Fwd: Pierre B Release Sampling

Unique identifier (REM/Spill/NOAV #, etc.): spill number 400914169, loc 443665

Subject: Re: Pierre B Release Sampling

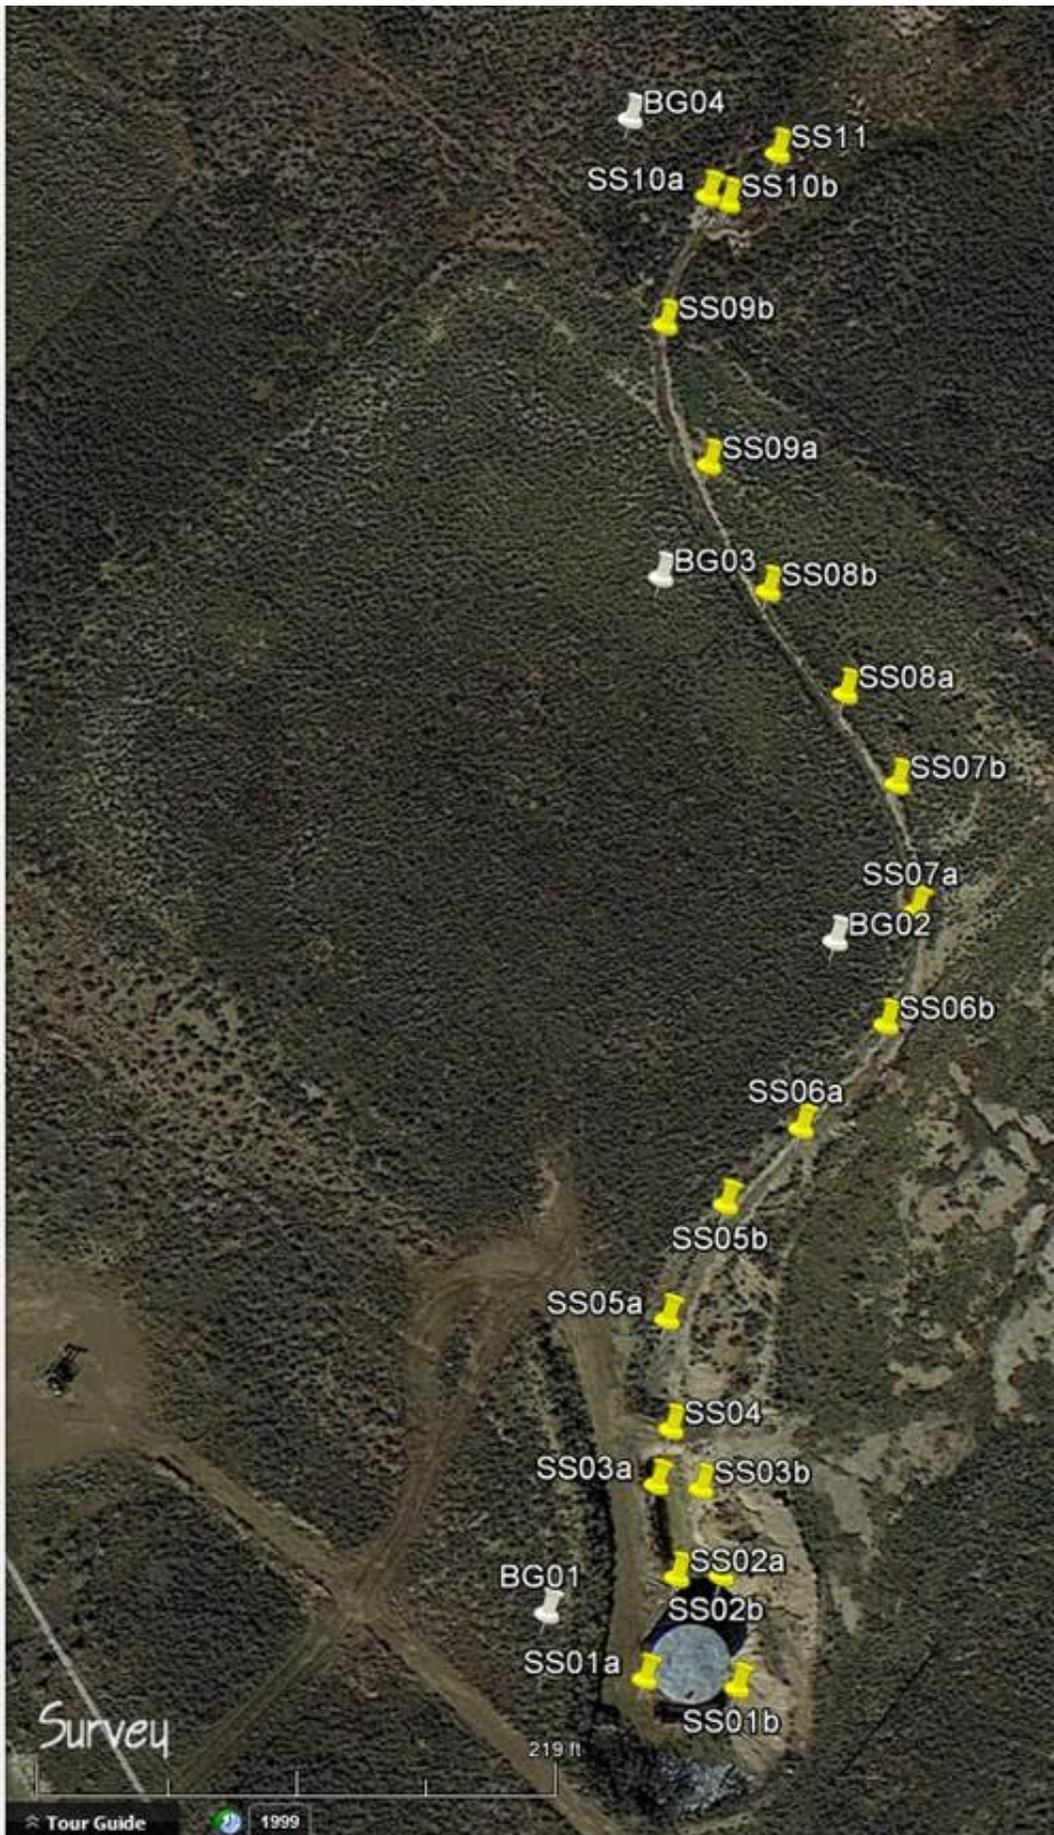
Below is the diagram depicting the samples that were already collected on 11/3/15 along the Pierre B Tank release. Your comments on the approved Supp. Form 19 indicate we needed to take three discrete samples from the "fan". We collected one discrete and one two-point composite from the "fan" area. This is slightly less than your requested amount. However, you only asked for one sample in the spill path. We collected one two-point composite every approximate 100 feet. This is significantly more than you requested in the approved Supp. Form 19. Are the already sampled locations ok?

Also, during a previous conversation you requested EC, pH, SAR data as a possibility. This was not on your request on the approved Supp. Form 19. Are we ok to stick with BTEX, TPH-GRO, TPH-DRO on all 11 samples?

2 samples from the Fan will be acceptable.

The already sampled location will be acceptable.

The only reason I omitted ec, sar and PH was because I believe there is a background SAR in the area, your BG

samples will clear that issue.

In short, your sampling, is acceptable. I will have this email uploaded to the database as record of the approval.
